Meeting of the Central Valley Flood Protection Board November 16, 2012 Staff Report

California Department of Transportation, District 10
Canal Creek Bridge Crossings at State Route 99, Merced County

Consider approval of Permit No. 18796 (Attachment B)

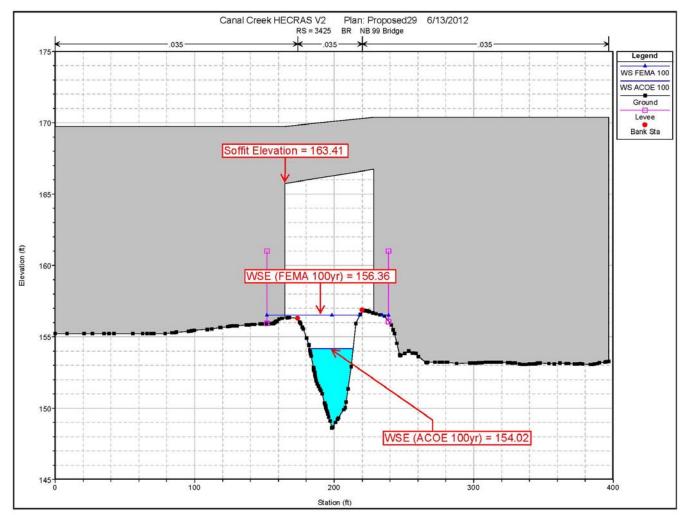
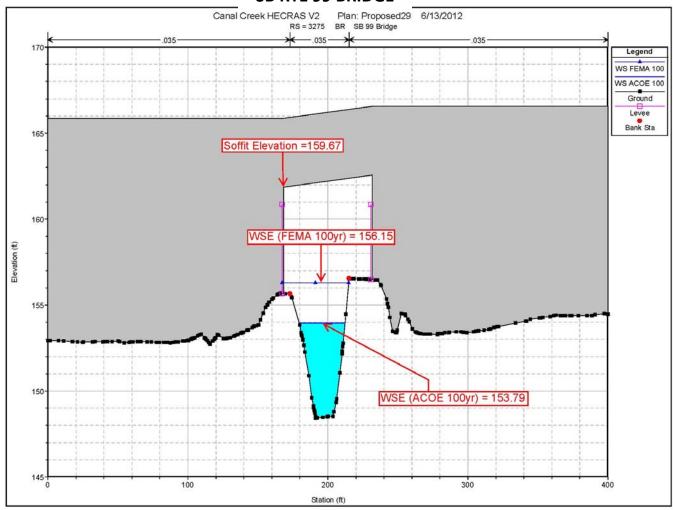
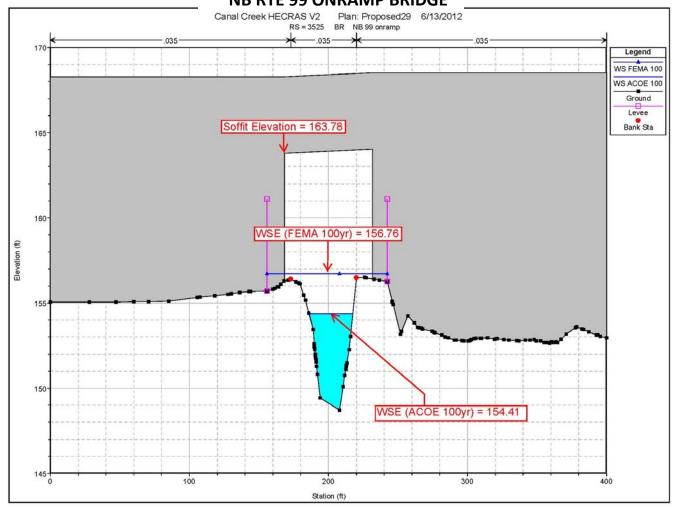
The modeling computed a 100-year WSE of 156.36, 156.67, and 156.76 feet at the proposed bridge locations for the northbound SR-99, southbound SR-99, and northbound SR-99 on-ramp, respectively. The proposed soffits of the new structures are at elevations of 163.41, 159.67, and 163.78 feet for the northbound SR-99, southbound SR-99, and northbound on-ramp, respectively. This results in respective freeboards of 7.05, 3.52, and 7.06 feet of above the FEMA 100-year WSE. This is consistent and compliant with CCR 23 standards which require a minimum of three (3) feet of freeboard above the design WSE.

Calculated velocities for the proposed project are approximately 4.5 feet-per-second (fps). The proposed project will result in a change in WSE of -0.10, -0.06, and 0.06 feet from pre-project conditions for the northbound SR-99, southbound SR-99, and northbound SR-99 on-ramp, respectively. Staff agrees with the determination that the modeled impact of is negligible (see Attachment D – Hydraulic Profile and Summary Table).

Staff agrees with Caltrans' assessment and conclusions from the Hydrology and Hydraulics Report and finds the project to be hydraulically compliant with CCR 23 and have no significant adverse affects on the Canal Creek.
